REPORT
OC/5.2/19.12

Subject: Marlborough Reserve - Consultation and Design

**MARLBOROUGH RESERVE
 AND PLAYGROUND UPGRADE**
 DRAFT CONCEPT DESIGN

PLAYGROUND CONCEPT PLAN SK-07

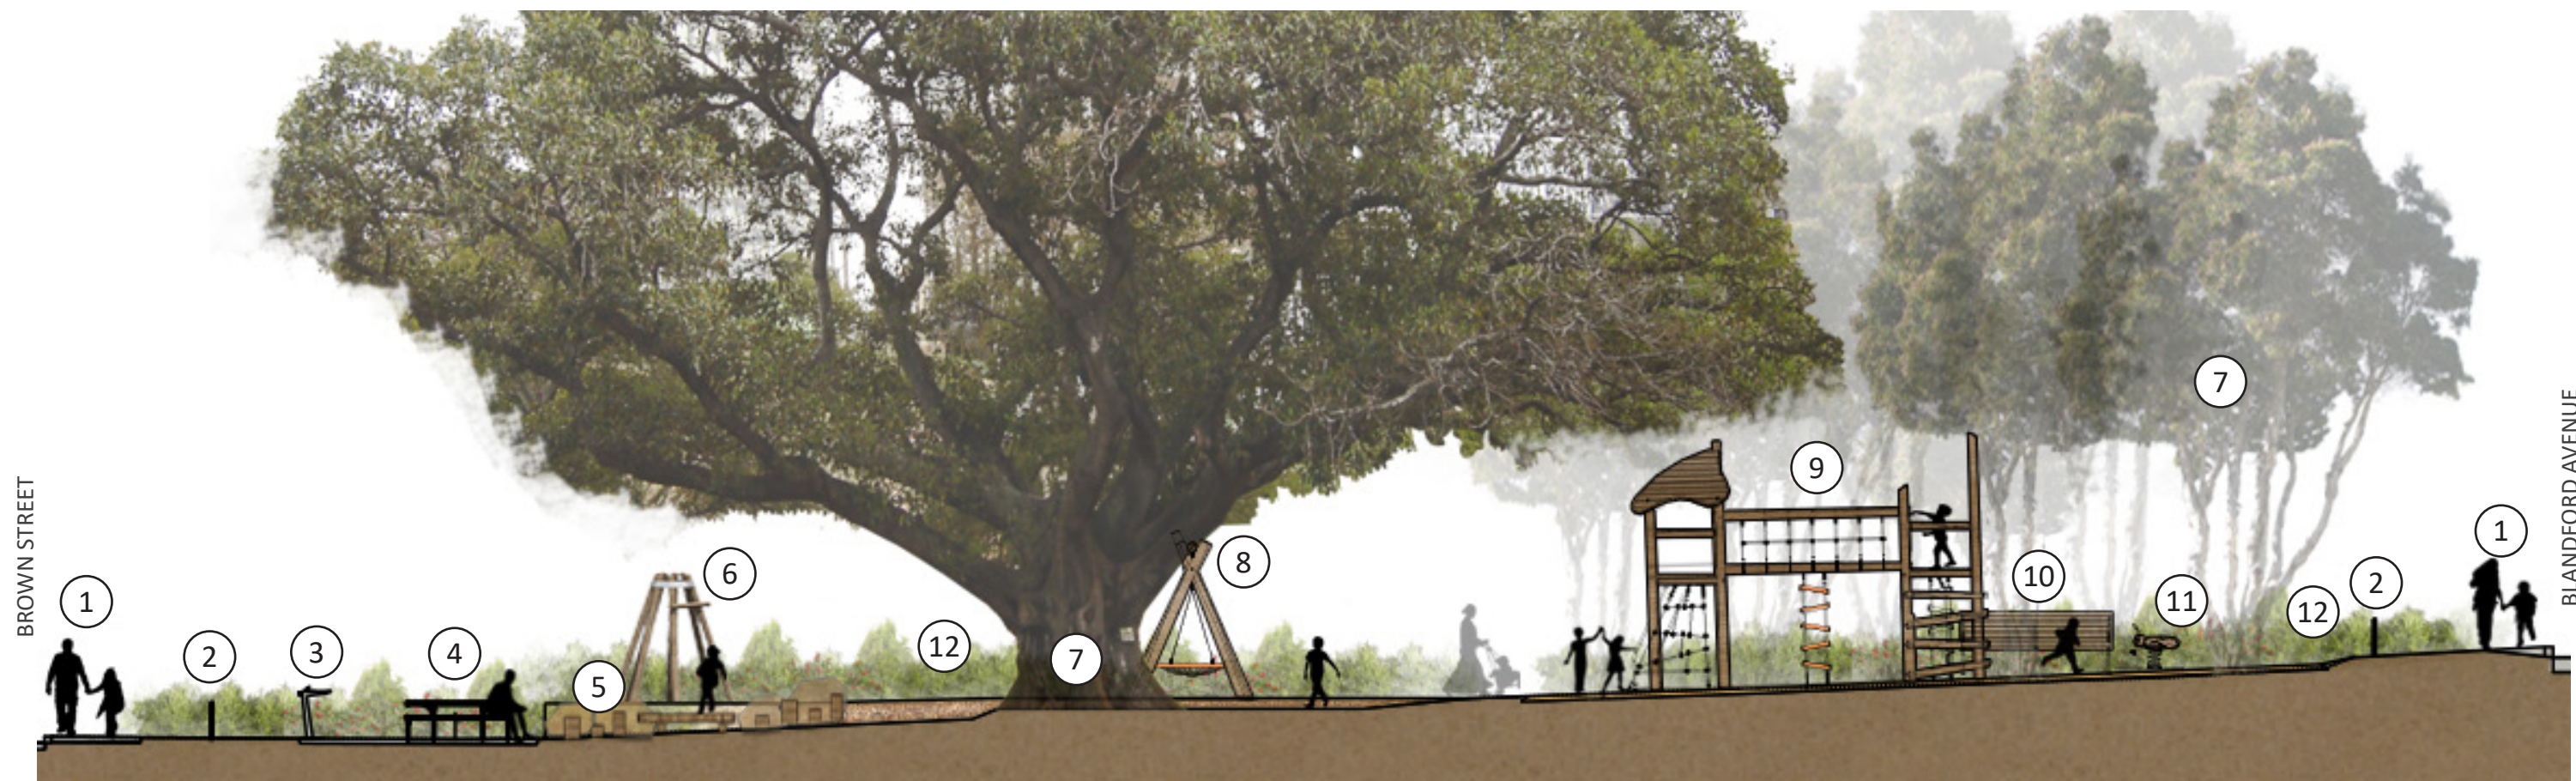
1. Too much play area. (it seems to have doubled) Not enough adult area. eg. picnic tables, exercise area, terracing. 2. prefer to have the pram ramps lower down Brown and Blandford. 3. Not enough new vegetation. 4. No plan for the lower slopes.

6. The Moreton Bay Fig Tree is a high value tree. You have identified the Tree Protection Zone (TPZ) around the canopy and base. The proposal does not meet the Council’s standards within a TPZ. See Appendix A. The proposal for an elevated embankment slide and climbing elements under the canopy of the Moreton Bay Fig tree will destroy the visual peacefulness of the park and the beauty of the tree. Nothing will grow under the tree so it cannot be concealed by planting.

Reference	Sheet	Description	Response
2	SK-07	Perimeter footpath around the reserve to link with existing footpaths.	<ul style="list-style-type: none"> Introducing a concrete pathway to the perimeter of park will destroy the natural beauty of the park. Walking and pushing prams on grass is part of the natural experience. I see people enter from and cross in many different directions. They rarely walk the boundary. Not all roads lead to the playground. There are no existing footpaths or goat tracks in the park.

The design was modified in-light of this feedback and the extent of the proposed footpaths were reduced. To ensure equitable access to the playground a perimeter footpath, kerb ramps and access paths were provided only to the playground. The access path to the playground was also modified to be a neutral coloured material to reduce the visual impact.

PROPOSED PLAYGROUND CONCEPT PLAN AND CHARACTER IMAGES SK-04

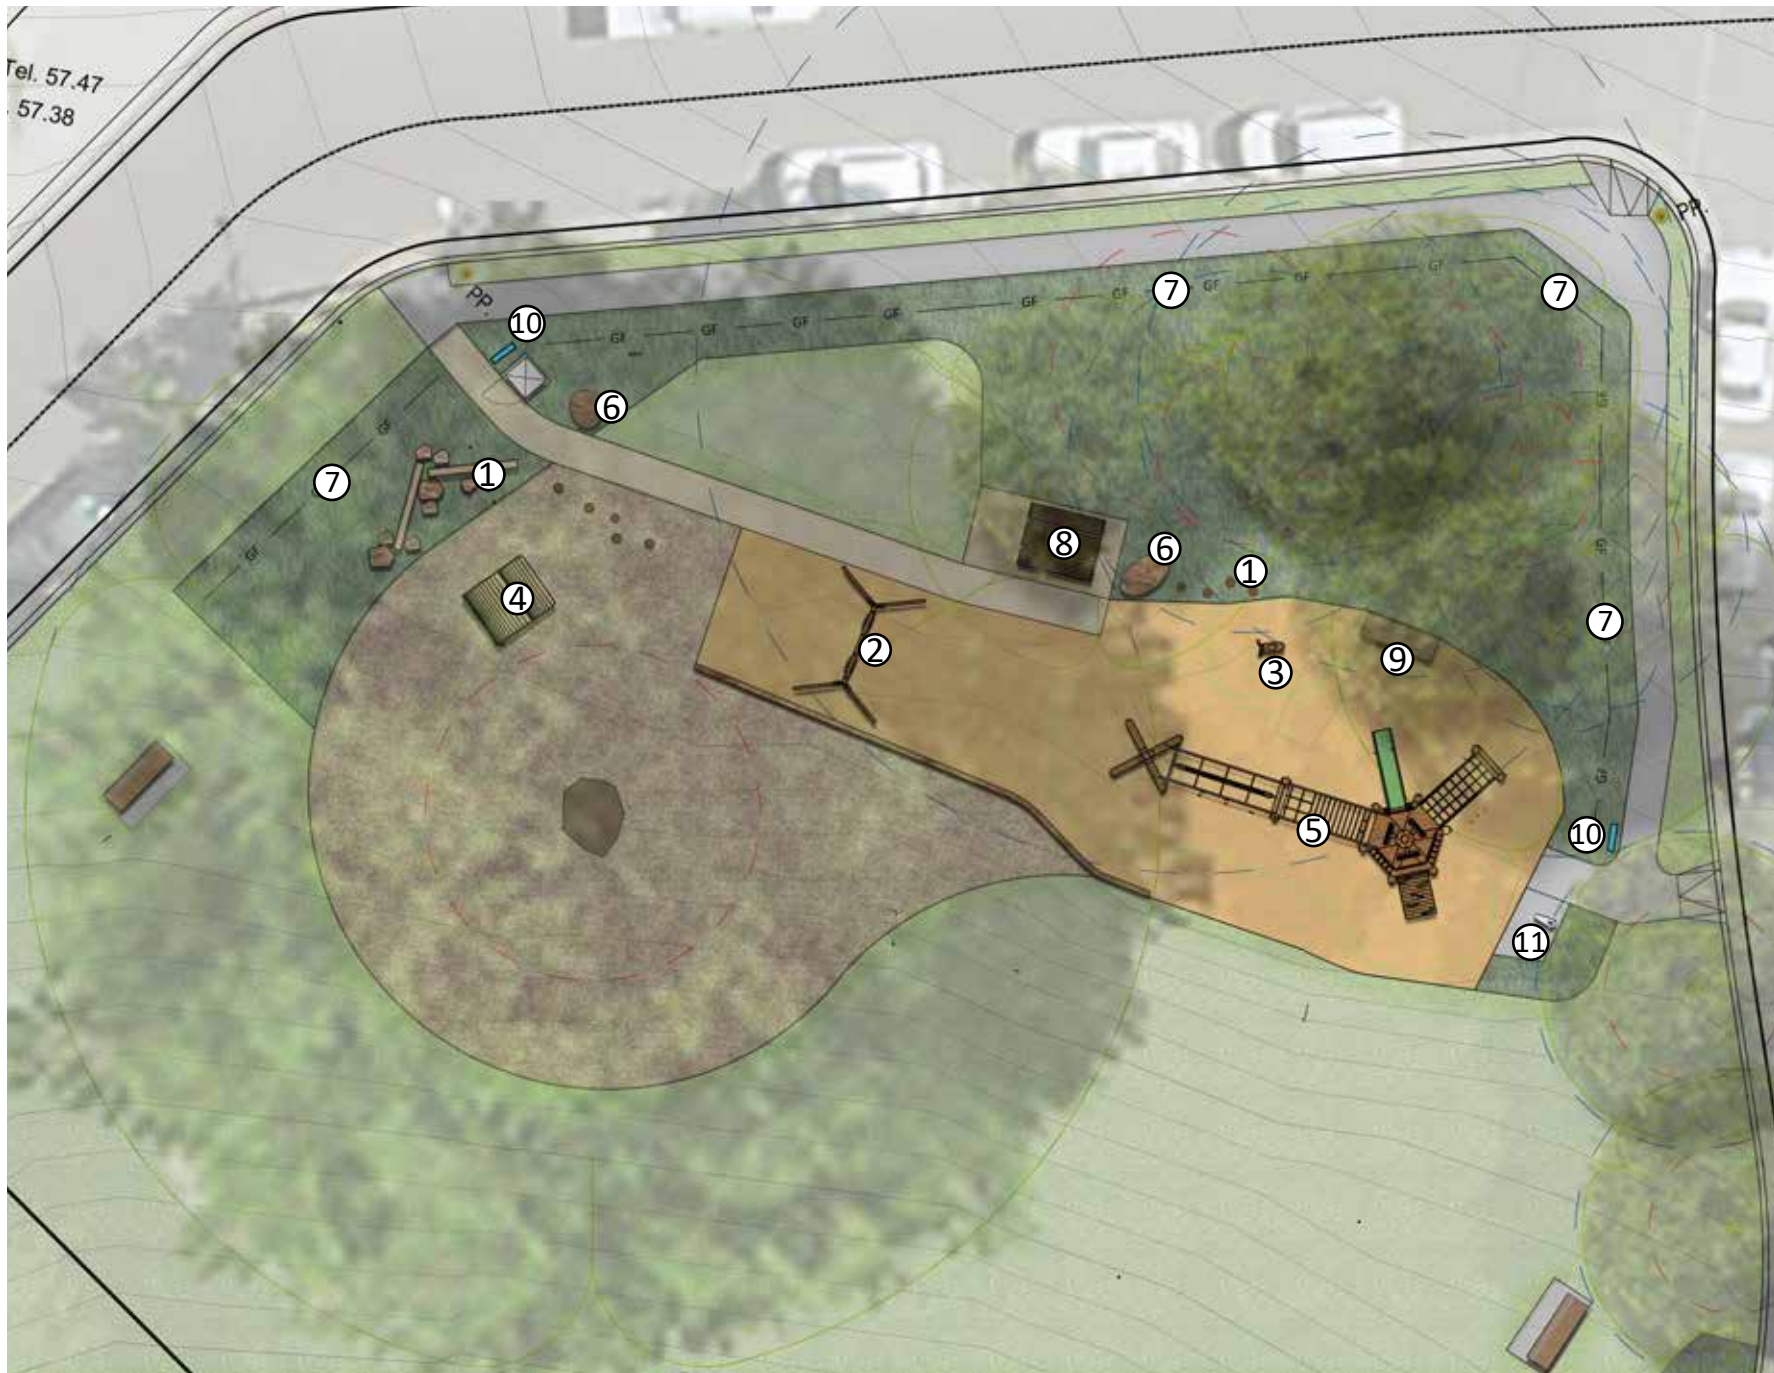
The colour of the cubby house is not blending in with the natural colours of the reserve. Please remove from design as location looks to be outside the current playground footprint extending the play area to current non-play area. Nothing, but I preferred the original concept.

Item 7,9 Slide aesthetic is awful, even with planting. Kids climb slides there is usually conflict + mud. Planting indicated at 9 does not obscure view from B'ford ave residents. Reject synthetic materials on slope. 7 plantings should be spec as low grass

The low looping fence is similar to the one at Bronte which is a trip hazard. You can't see it in amongst the tall grass. Please change to something more visible both to stop children running on the road and to stop grandparents falling over.

- Retain the proposed extent of the soft-fall.
- Ensure the soft-fall installed is a neutral colour.

Maintain the proposed barrier to the road, in the form of planting and garden hoop fence, particularly where play equipment is located less than 30 metres from the road frontage to ensure adequate safety.
